**HEARING REPORT – VOLUME ONE**

**FIVE NOTICES OF REQUIREMENT**

**AIRPORT TO BOTANY BUS RAPID TRANSIT**

**THE SUPPORTING GROWTH ALLIANCE**  
**(AUCKLAND TRANSPORT AND WAKA KOTAHI**  
**NZ TRANSPORT AGENCY)**

Excerpt Unitary Plan Map showing NoR1 affecting 18m<sup>2</sup> of 18 Srah Place along northern frontage to Smales Road.

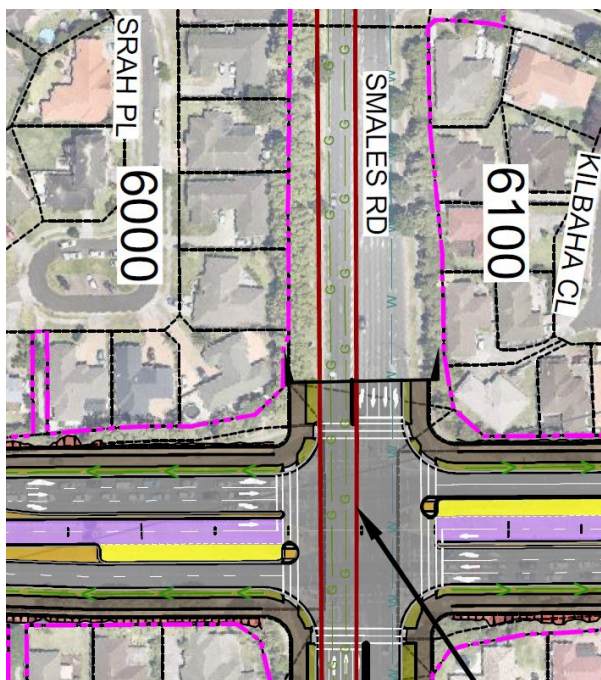
NoR1 Form 18 Attachment A – Designation Plans Sheet 2 is a map showing the properties and the proposed designation boundaries, with the Property ID referencing the proposed designated part of 18 Srah Place, as follows (excerpt)(note the map is not aligned with North upwards, but rotated to fit the page). 627311 identifies the 18m<sup>2</sup> required from 18 Srah Place:

The Unitary Plan maps are searchable by address, and if '18 Srah Place' is searched the map zooms in on the property and provides a list of Unitary Plan information about the property, including whether there is a Notice of Requirement (NoR) or Designation applying to the property. If that NoR is selected the map will show in red shading the extent of the designation. If there is no Designation or NoR listed against the address searched, then it cannot be selected to turn on the red shading. In order to show the extent of the Designation or NoR near those properties, search the address of a nearby property that is directly affected, select the NoR and the map of the area will show the whole red shaded NoR.

Figure 7: NoR 1 – Rongomai Park to Puhinui Station

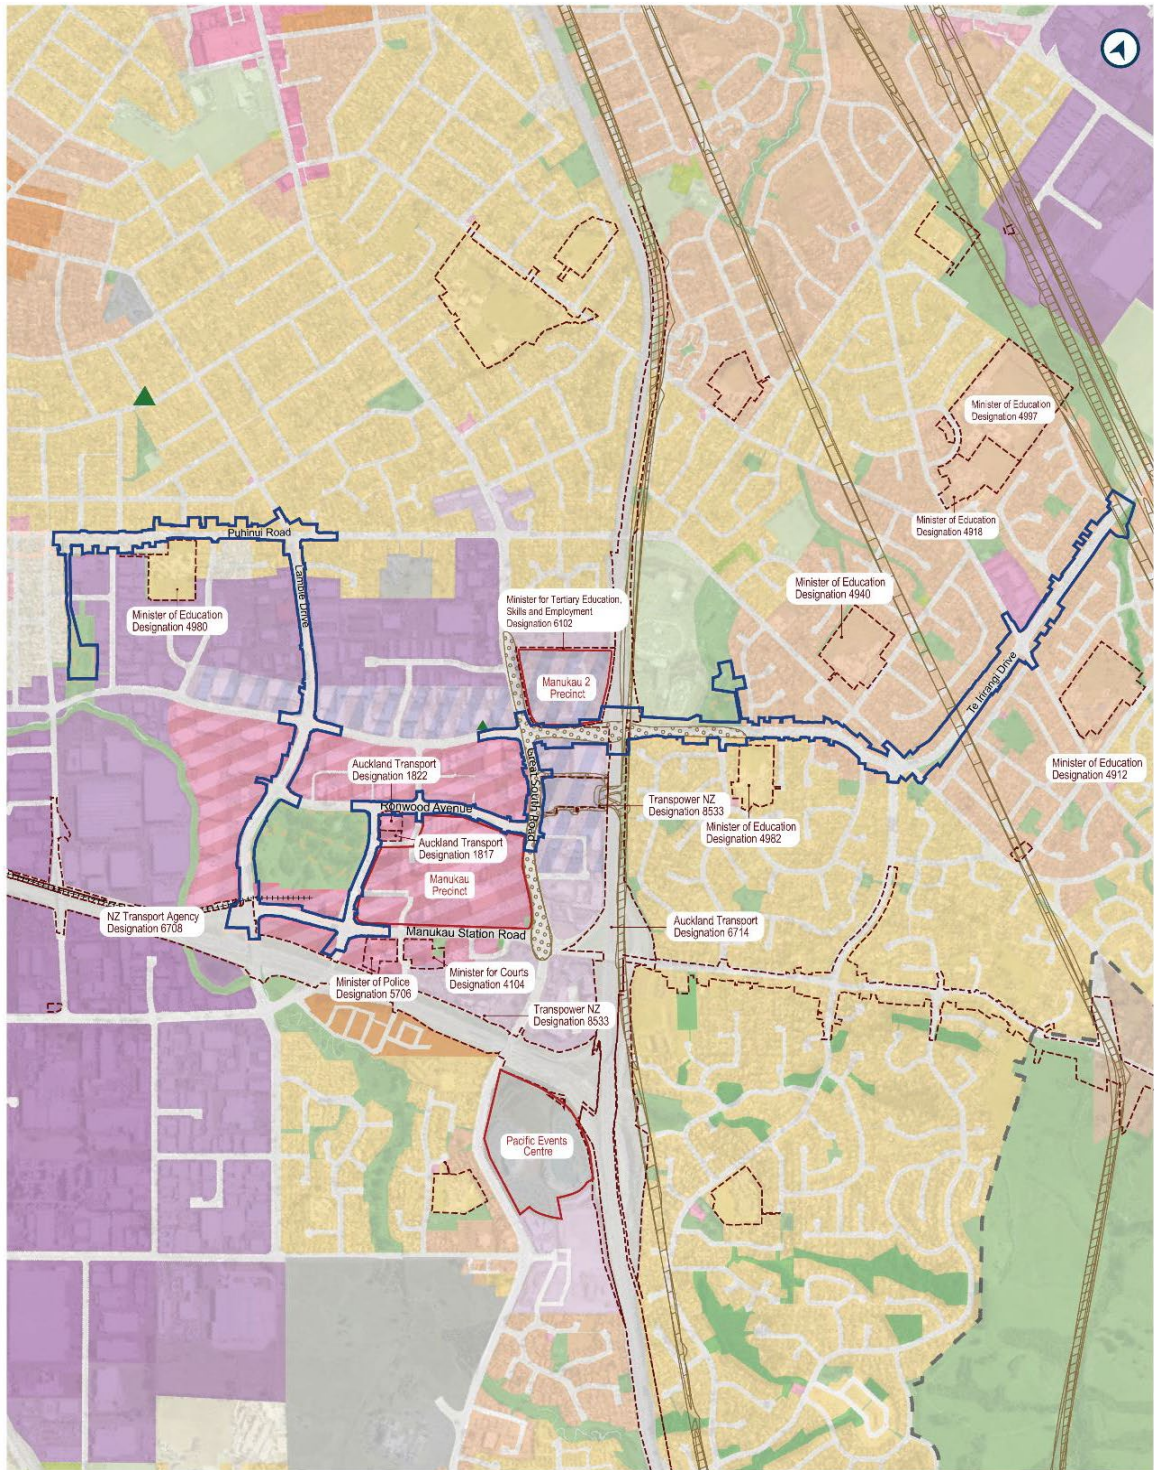
- 8.3 The extent of NoR 2 is depicted in Figure 7. The locations of the five BRT stations are also depicted in Figure 7 through the greater extent of the corridor at Dawson Road and Diorella Drive on the eastern side of SH1, Ronwood Avenue in the heart of Manukau Town Centre, a station linking in with the existing bus and train stations by MIT and a station at the corner of Lambie Drive and Puhinui Road. There are ten existing signalised intersections, some of which correspond to the BRT stations. Three new signalised intersections are proposed, relating to areas of high activity.

- 8.4 The General Arrangement Plan for NoR 2 depicts that the land taken to widen the corridor in this location includes a number of existing residential properties, particularly on the eastern side of SH1. On the southern side of Te Irirangi Drive some large sections of cut are proposed, particularly between Dawson Road and Hollyford Drive. At present very little detail is provided on the cut and fill batters. Where these are located adjoining private properties, it is expected that all solutions should be explored including whether low retaining walls could provide a solution that requires less land take. While not specifically an urban design issue, I note there are a number of rear lots on the northern side of Te Irirangi Drive within this same location. I assume access to these will be maintained when the front properties are acquired. If not, then arguably that should form a condition of consent.

Figure 9: NoR 3 Puhinui Station to SH20/SH20B

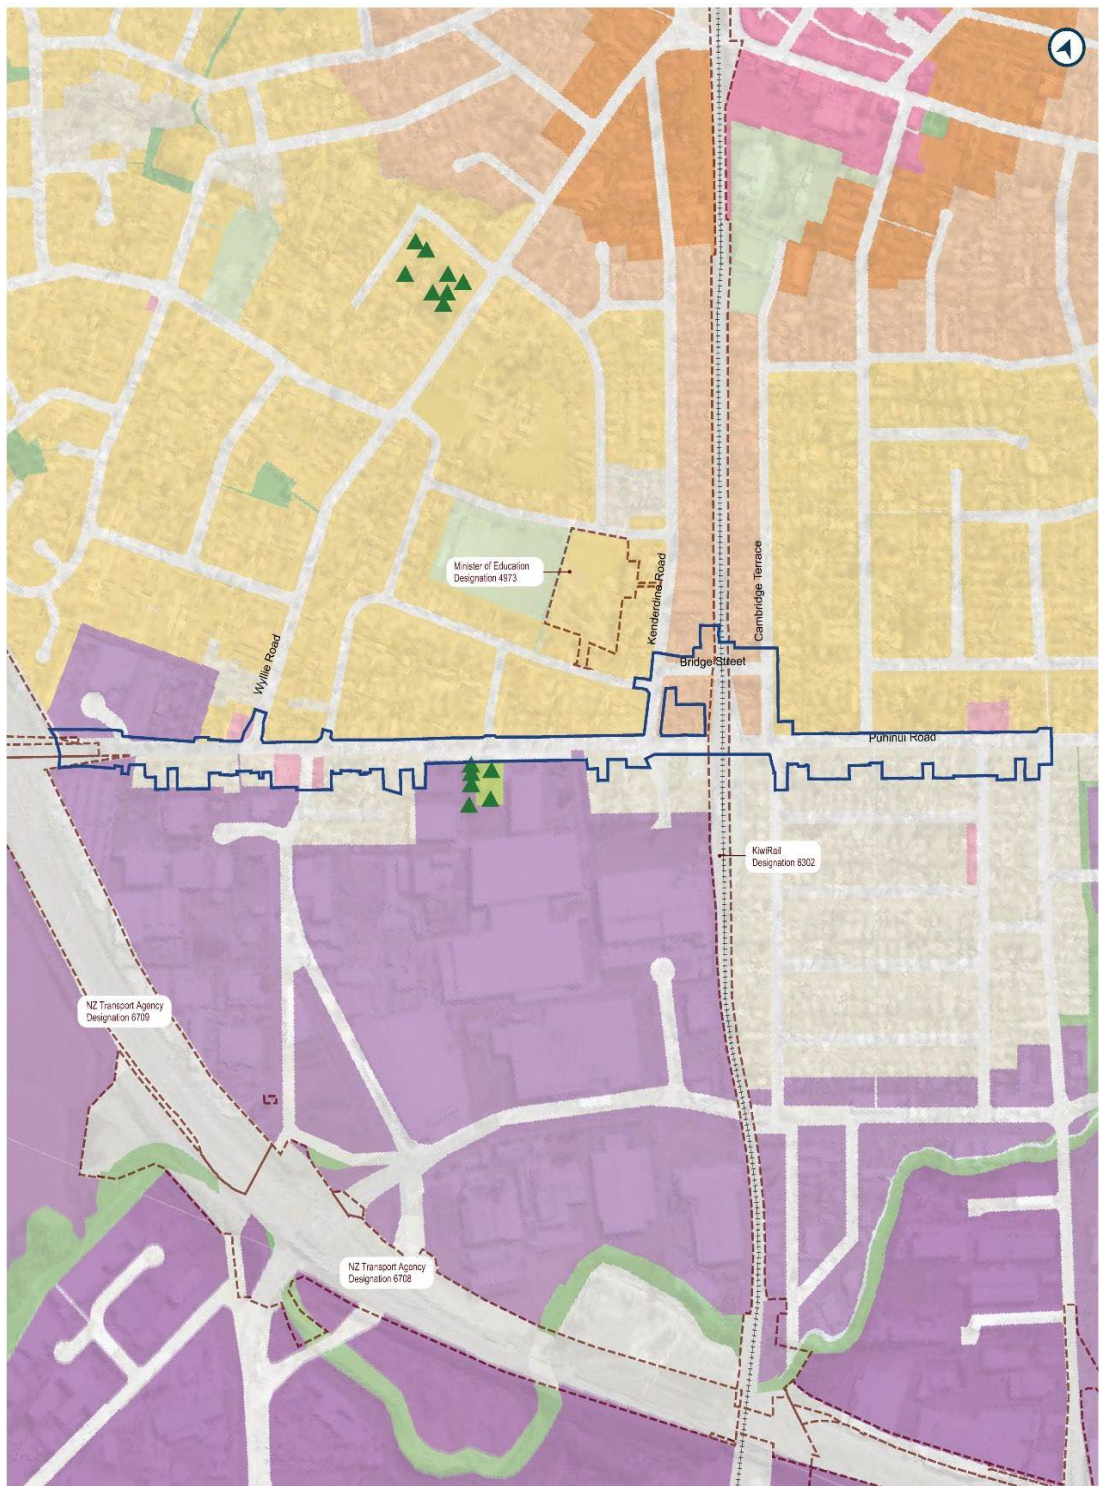
10.4 The General Arrangement Plan for NoR 3 depicts that the land take to widen the corridor in this location includes a number of properties, particularly along the southern side of Puhinui Road within the vicinity of the proposed bridge to Puhinui Station. From an urban design perspective the bridge structure has the potential to have the greatest negative impact on the immediate residential environment. This has been picked up by the UDE as something that requires inclusion within the ULDMP as set out in paragraph 10.5 below.

Figure 2: Excerpt from NoR 1 drawing Kellaway Drive Reserve

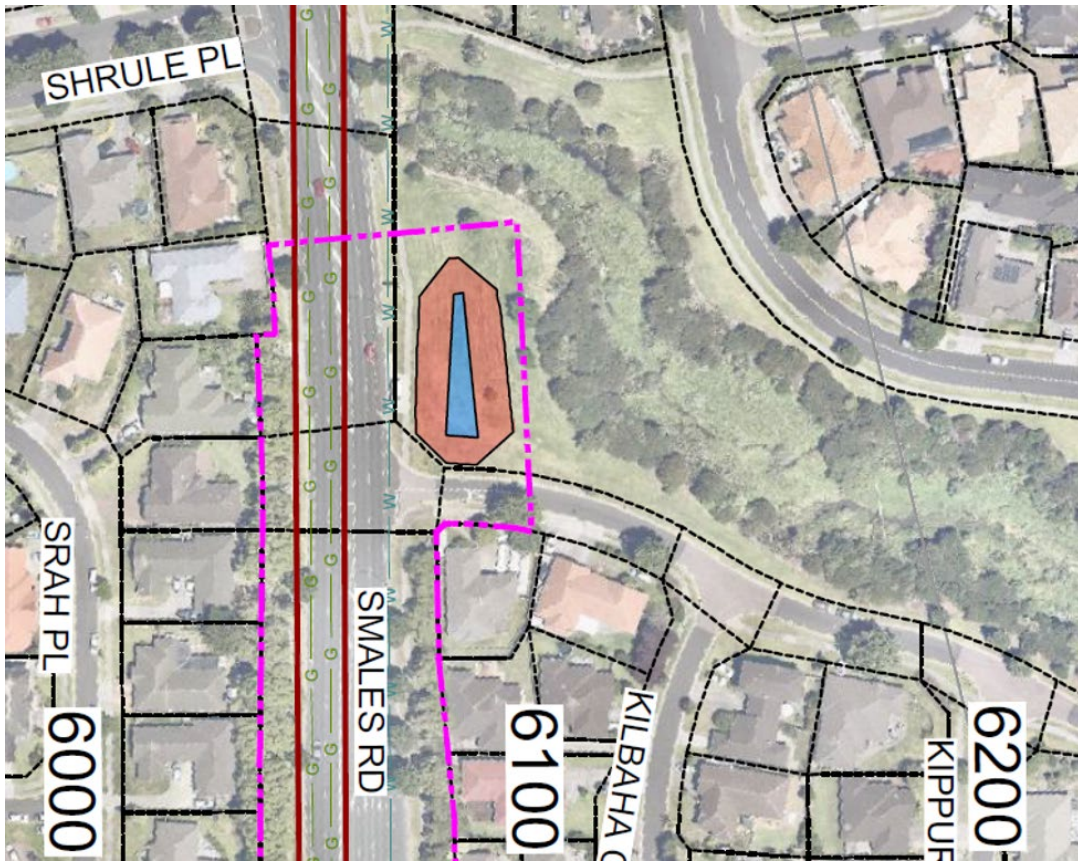
- 9.6 At the Smales Road end of the reserve, the NoR occupies the corner of the Kellaway Drive Reserve with a stormwater pond located within an open grassed area.

Figure 5: Excerpt from NoR 1 drawing Kellaway Drive Reserve

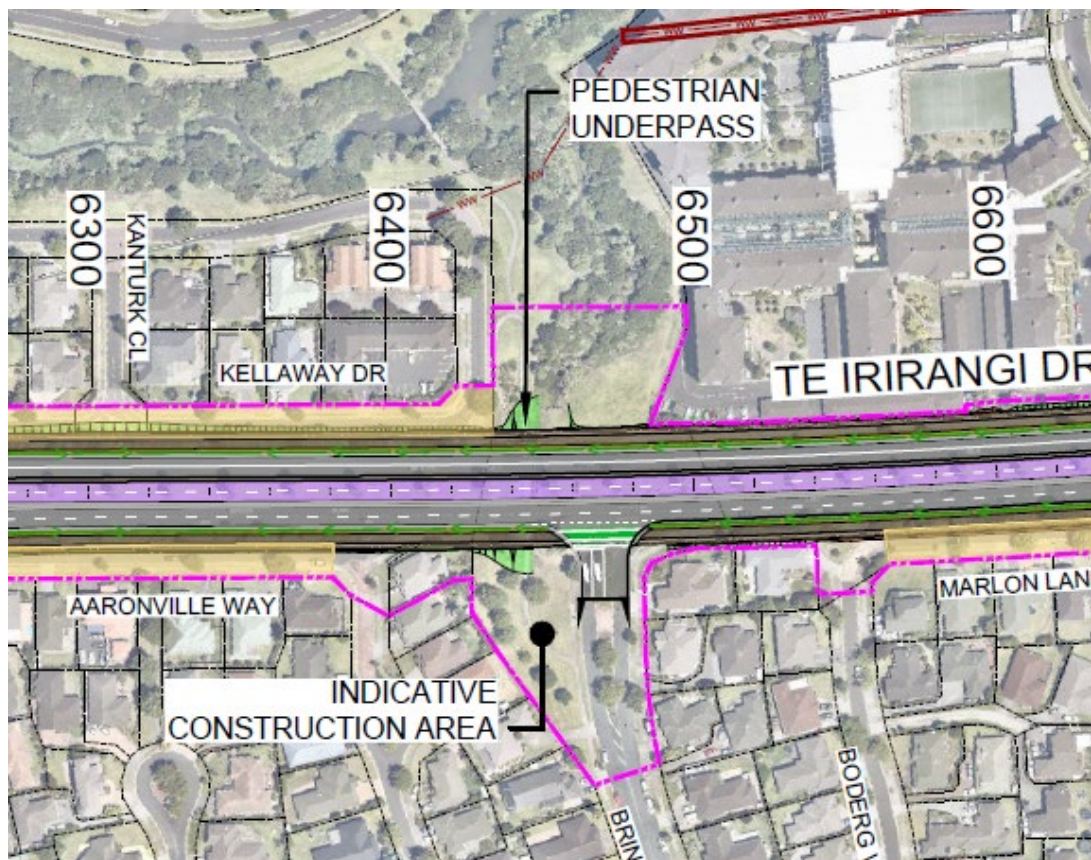
- 9.12 The proposal will result in widening of Te Irirangi Drive and a relatively small amount of encroachment into Kellaway Drive Reserve for the road and edge battering. The NoR footprint provides for a construction area within the reserve which would be reinstated post-construction.

Figure 6: Excerpt from NoR 1 drawing Sancta Maria Ponds

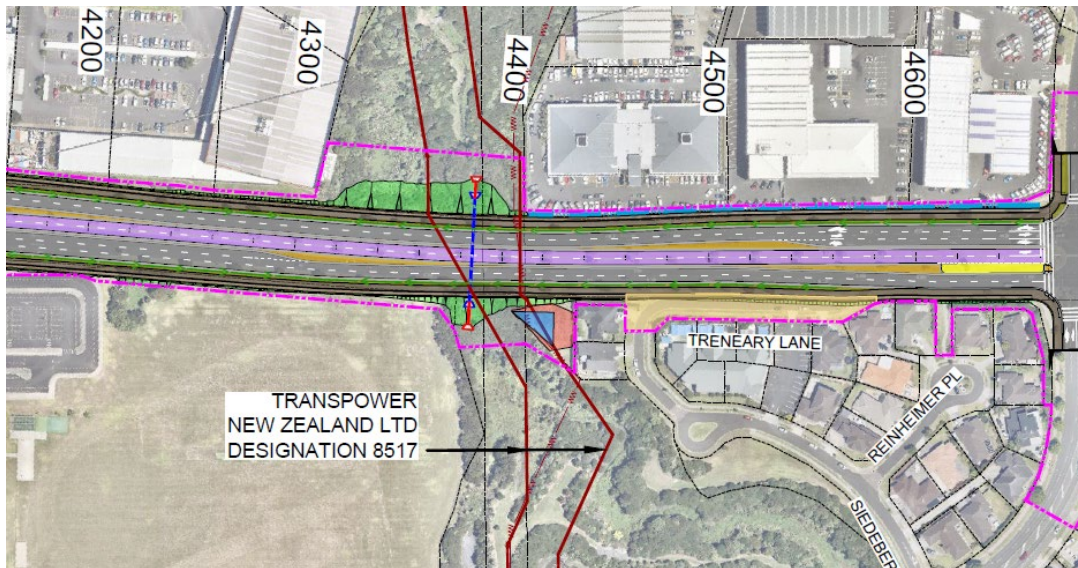
- 9.16 The Sancta Maria Ponds open space is a reserve area which is primarily developed for stormwater purposes, however, also has open grassed areas and an informal path network.
- 9.17 The project will affect the reserve at the interface where Te Irirangi Drive will be widened. The works will result in a relatively small area of permanent occupation, batters, and a temporary construction area.

- 9.18 The primary connection from Te Irirangi Drive into the reserve network is from Treneary Lane, and the project will be required to retain this connection.
- 9.19 Overall, the effects on Sancta Maria Ponds are assessed to be acceptable and will be managed appropriately via the proposed UDLMP and Ecological Management Plan conditions.

Figure 16: Manukau Sports Bowl – NoR areas

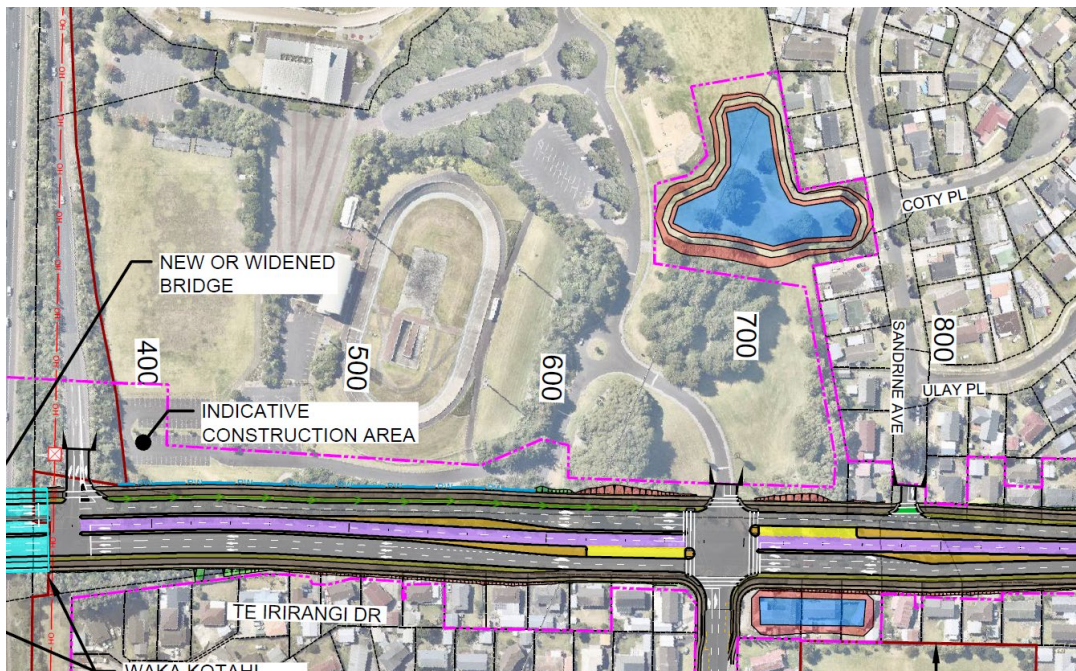
10.22 The NoR area also extends up the eastern boundary and doglegs into the park opposite the Sandrine Avenue entrance. This area is intended to be occupied by a stormwater treatment device to service the needs of the A2B project.

- 10.23 The area of land proposed to be designated within the Manukau Sports Bowl is identified within the Masterplan as both the location of a children’s hub including a playground, splash area, and nature playground and amenity planting. However, more significantly, this area is also the land identified as suitable for development anticipated as a funding source to enable wider development of the park.

Figure 18: Hayman Park – NoR areas

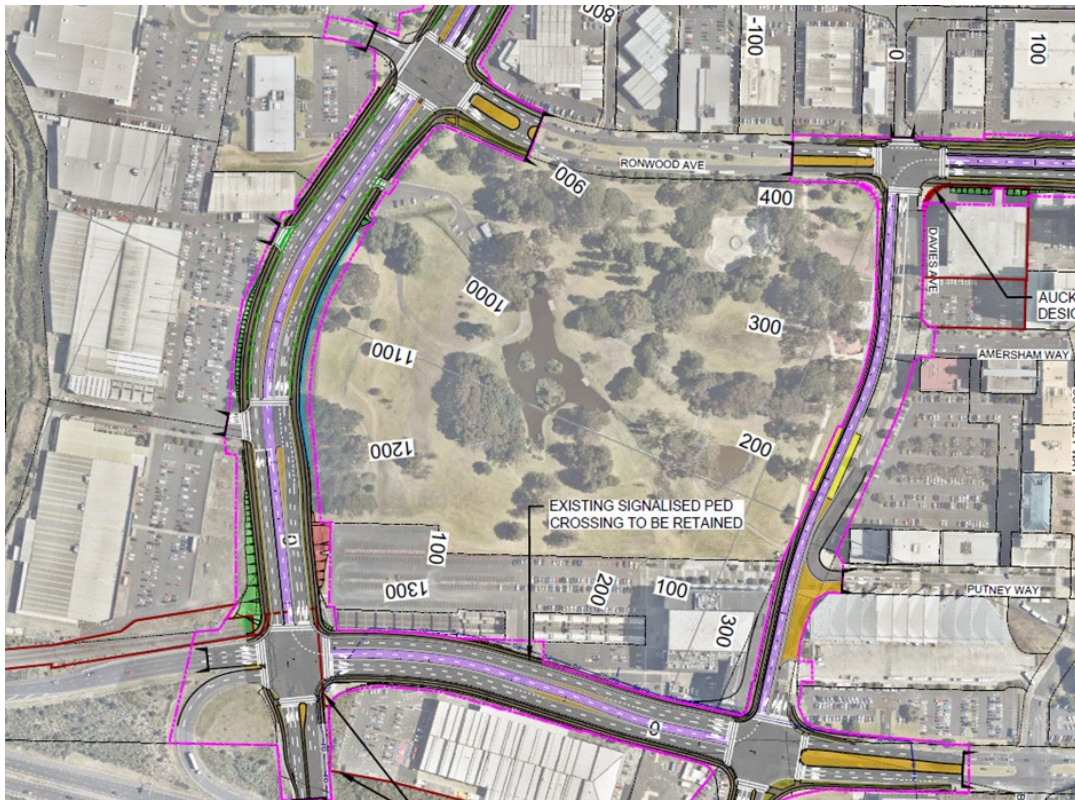
- 10.40 Public parking is located along Davies Avenue which has been developed with a landscaped median including pedestrian access and a wide plaza type connection to Manukau central to the east. Limited public parking is available on Ronwood Avenue.
- 10.41 The eastern boundary of the park is flanked by Manukau Station.
- 10.42 The NoR area is located alongside the Lambie Drive and Davies Avenue frontages and returns along Ronwood Avenue.
- 10.43 Construction is likely to result in restricted access to Hayman Park. The project will result in permanent changes to the park interface with surrounding streets, and significantly to Davies Avenue which provides the pedestrian connection to east.
- 10.44 Proposed amendments to the UDLMP and CTMP and SCEMP conditions would mitigate these concerns.

- 10.45 Pre-lodgement, the intention of the requiring authority was to designate a central area for stormwater purposes. Following a successful collaboration process between council, Eke Panuku and the Requiring Authority a draft “Hayman Park Integration Framework” has been developed (March 2023).

Figure 20: Puhinui Domain – NoR areas

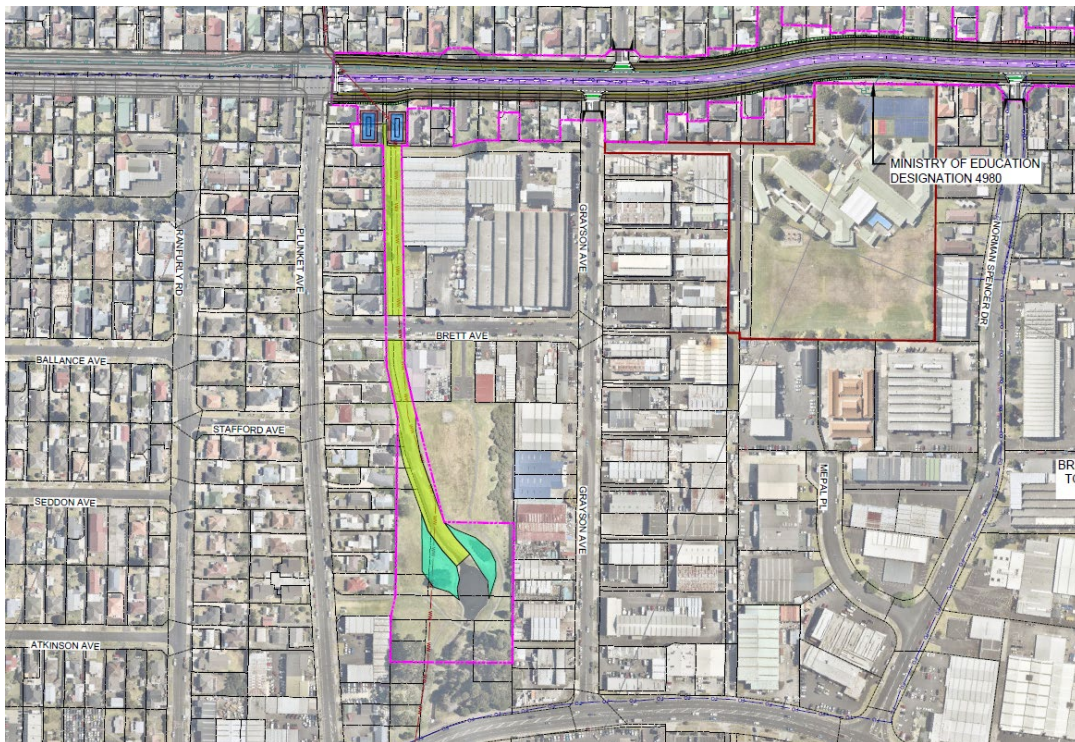
10.53 The proposal is to use and develop Puhinui Domain for stormwater management purposes, including the naturalisation of the existing concrete lined channels and a larger pond area at the southern end.
